Detailed Site Plan Alternative Compliance Advance Auto

**DSP-21034
AC-23003**

SUBJECT: Detailed Site Plan DSP-21034
 Alternative Compliance AC-23003
 Advance Auto

Figure 1: Site Plan

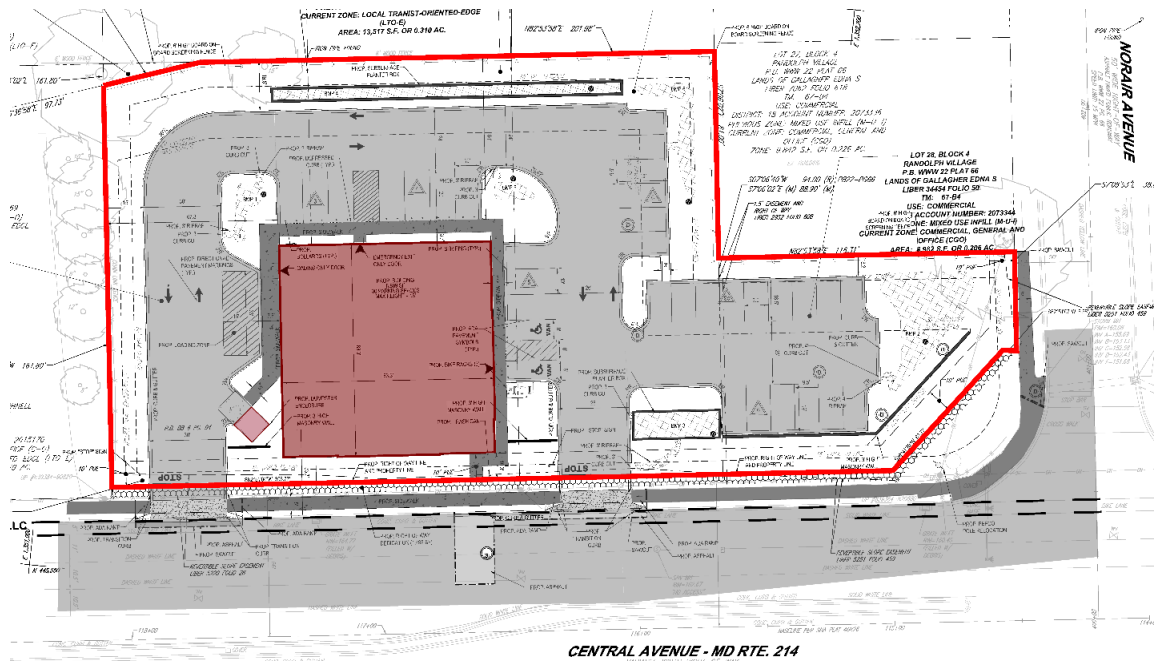
- B. APPROVAL of Detailed Site Plan DSP-21034 and Alternative Compliance AC-23003, for Advance Auto, subject to the following conditions:
 - 1. Prior to certification, the applicant shall revise the detailed site plan (DSP) as follows, or provide the specified documentation:

- f. On Sheet DSP-4, add labels indicating the location where the detail can be found for various site features (such as bollards, dumpster enclosure, masonry wall).

- g. Show the location of awnings on the site plan.
- h. Label the dimensions of the building bump-outs on the southern and eastern facades.
- i. Extend the masonry wall along the south side of the subsurface planter box located near the intersection of MD 214 (Central Avenue) and Norair Avenue.

- j. On Sheet DSP-4, show the location of all on-site pole-mounted light fixtures.
- k. On Sheet DSP-4, revise the Site Requirements as follows:
 - (1) Revise the building setbacks to reflect the required setbacks, in accordance with the 2010 *Approved Subregion 4 Master Plan and Sectional Map Amendment*.

- (4) Revise the parking space dimensions to provide the number for each type of parking space provided.
 - (5) Revise the Maximum Building Height provided, to list the building height as shown on the architectural elevations.

- (6) Verify the percent ground cover area listed on Sheet DSP-4 and revise the Green Area Calculations note accordingly.
- l. On Sheet DSP-4, revise the Sign Requirements as follows:

- (2) Correct the sign requirements to reflect the proposed use on the subject property.
 - (3) Delete the reference to the freestanding sign.
 - m. Show the crosswalk striping, per the detail provided on Sheet DSP-8, on the site plan.

- n. Revise the color of the bicycle racks to red, to match the color of the building-mounted sign and awnings.
 - o. Provide details for the proposed trash can located along the south side of the building.

- p. Provide details for the concrete pad located in front of the trash enclosure.
 - q. On the Lighting Plan, correct the location of the building-mounted light fixtures to align with the building footprint and the location of doorways.

- r. Remove the details of the temporary sign.
 - s. On Sheet DSP-14, add a note stating where the location of the building-mounted signs may be found.

- t. Provide dimensions from the property boundaries to the proposed building.
2. Prior to certification, the applicant shall revise the landscape plan as follows:

Figure 4: Build-To Line and Setbacks exhibit from the master plan

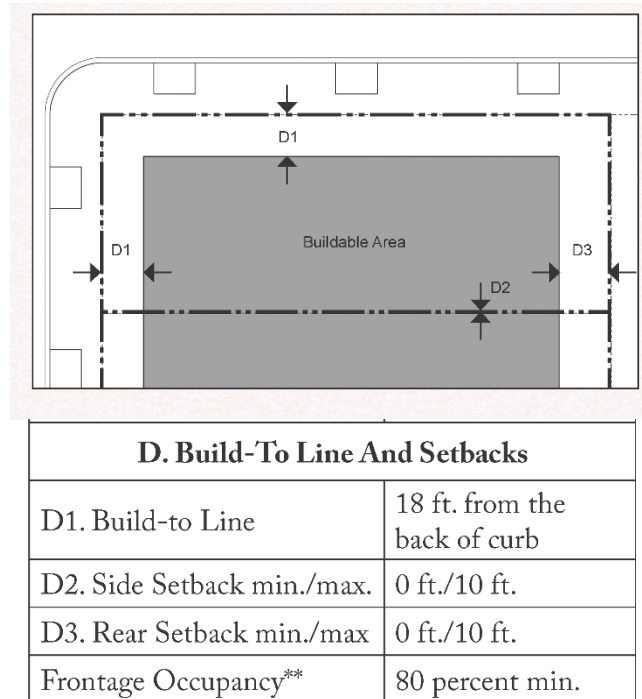
Due to the unique circumstances impacting the subject property, it is not possible to conform to these standards, necessitating a request for an alternate development district standard.

The proposed building is located 23.5 feet from the back of the curb. This setback requires an alternate development district standard. The setback is necessary to provide a 10-foot-wide public utility easement (PUE), which was not contemplated in the master plan, and does not permit any setbacks to the front build-to line. The PUE is required by Condition 3.a. of PPS 4-22042, which was approved for the subject property. Due to the requirement to establish the PUE, the applicant is not able to conform to the 18-foot build-to line requirement.

To the extent that the build-to line requirement also applies to Norair Avenue, the frontage along this street is limited to the extent that conforming to the build-to line on Norair Avenue is impossible. Also, the proposed building does not conform to the required 10-foot side and rear yard setbacks. The subject property is abutted by single-family detached homes. The 2010 *Prince George's County Landscape Manual*

In addition to the build-to lines and setbacks, a frontage occupancy requirement of 80 percent is established. The proposed building occupies 27 percent of the property frontage. However, two circumstances support granting this request for alternate standards. First, as noted above, the property has a narrow frontage on Norair Avenue, which does not have sufficient width to locate a driveway, much less a building. This narrow depth extends for a third of the subject property's frontage on MD 214 and practically prevents compliance with this standard. Two access driveways are also provided, which account for another 16 percent of the property frontage. Thus, strict conformance with this standard is not possible. However, the master plan allows the use of a masonry wall to help meet the frontage occupancy requirement when attached to the primary building. The applicant proposes to provide a 3-foot-tall masonry wall. The wall extends from the east and west of the building to each of the driveway aisles. The wall then extends along the remaining frontage of MD 214 to Norair Avenue. A total of 97 linear feet of wall is provided. However, the wall is not attached to the building, to allow for pedestrian circulation to the sidewalk on MD 214. The total distance of the wall, combined with the width of the building, brings the frontage occupancy to 58 percent. The applicant should provide a site elevation of the property, as visible from MD 214 and Norair Avenue, to demonstrate how their proposed 3-foot-high wall, landscaping, and lighting will benefit the development and mitigate the impact of the requested alternate standards.

Based upon the above justification, the proposed development complies with the intent and spirit of the requirement. The requested alternate standards will benefit the development and the development district and will not substantially impair implementation of the master plan. These modifications will not negatively impact the project or alter the intent of the standard to construct buildings close to the street. Therefore, staff recommend **approval** of these requested alternate development design standards.
